ZONING CHANGE REVIEW SHEETCASE: C814-97-0001.14DISTRICT: 6

(Leander Rehabilitation Planned Unit Development Amendment #15-
Texas Children's Hospital North Campus)

ZONING FROM: PUDTO: PUD*

* The applicant is asking to amend Ordinance No. 20190620-154 to permit an alternate internal drive design for the interior streets on parcels CO-1 and COR-4 (*please see Applicant's Request Letter and Redlined Ordinance – Exhibit C*)

INTERNAL DRIVE EXHIBIT PUD AMENDMENT	DRAWN BY:
	May 28, 2021
	CHECKED BY:
	1" = 60'

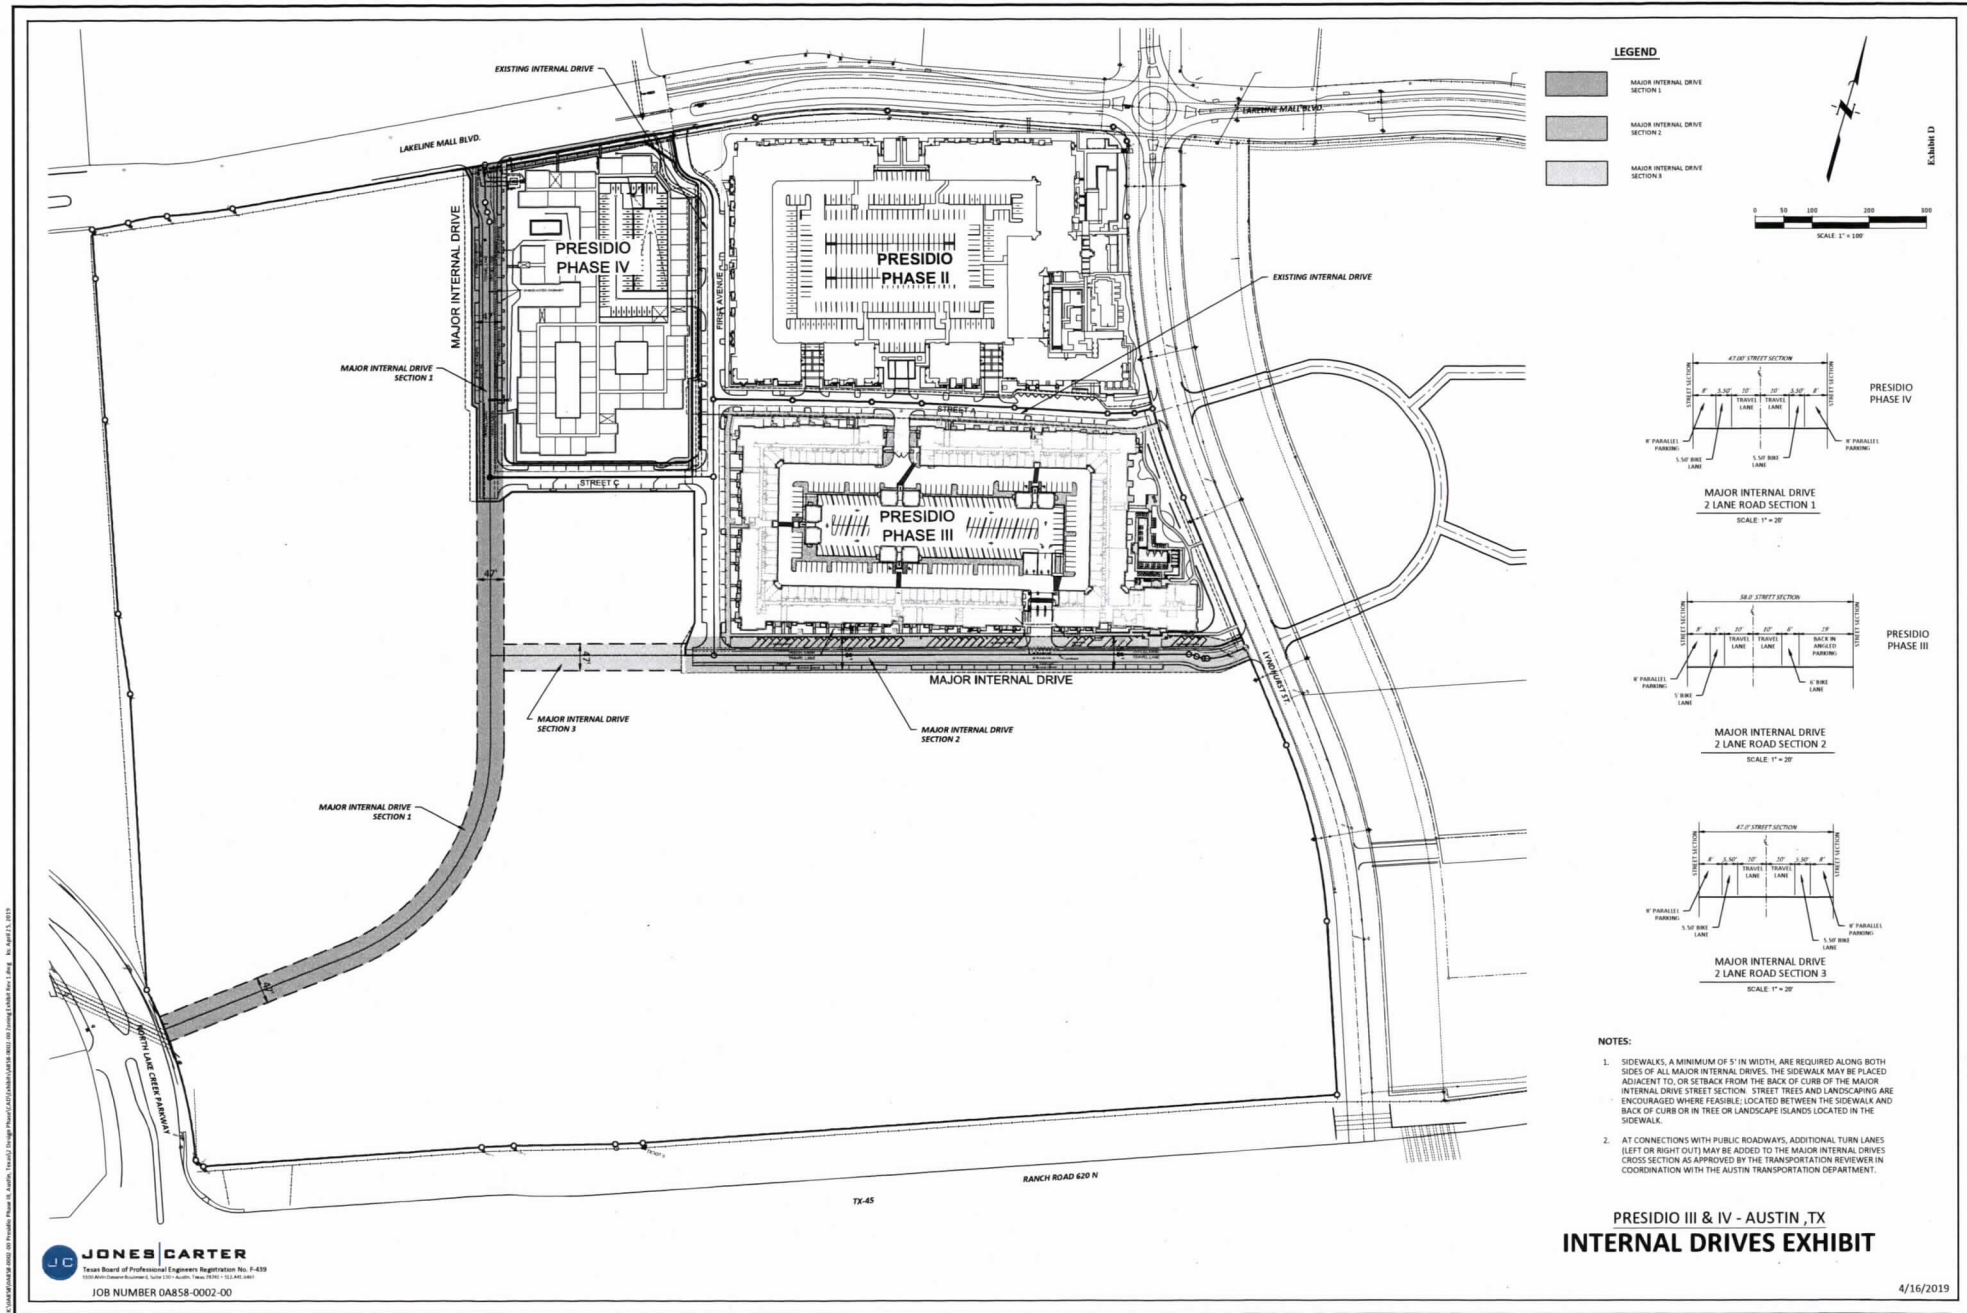
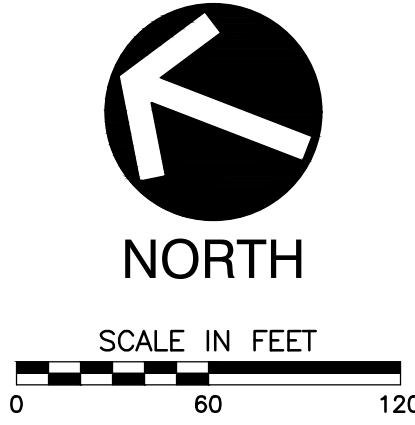
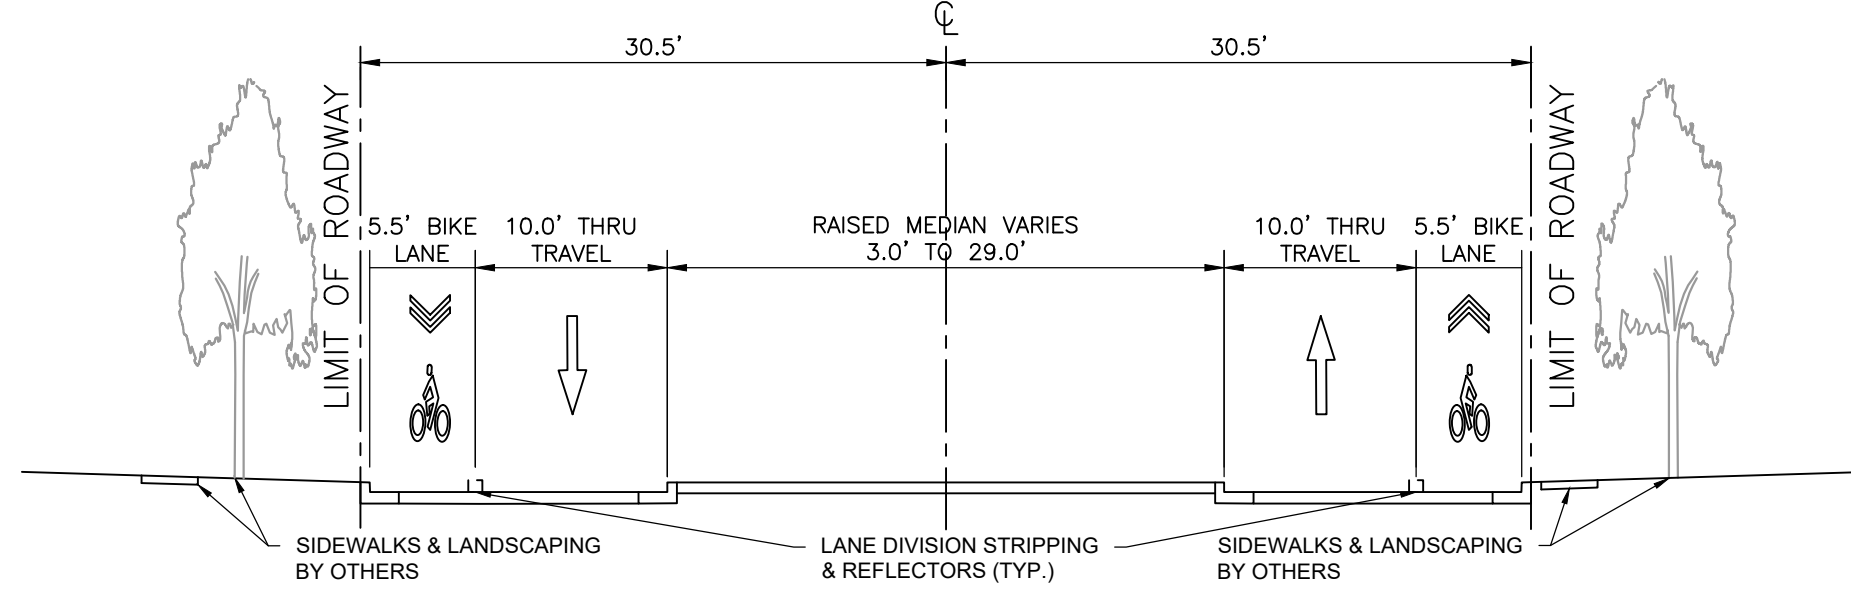
Street section C is only acceptable if the lane is not adjacent to proposed buildings. If the lots have near zero lot line setbacks then a 20 foot wide travel lane & bike land is needed for a divided road. Please verify compliance. Based on the proposed plan Street C is adjacent to a proposed building, as such Street C will need to provide sufficient width for operations. The comment response is verified with the hospital plans.
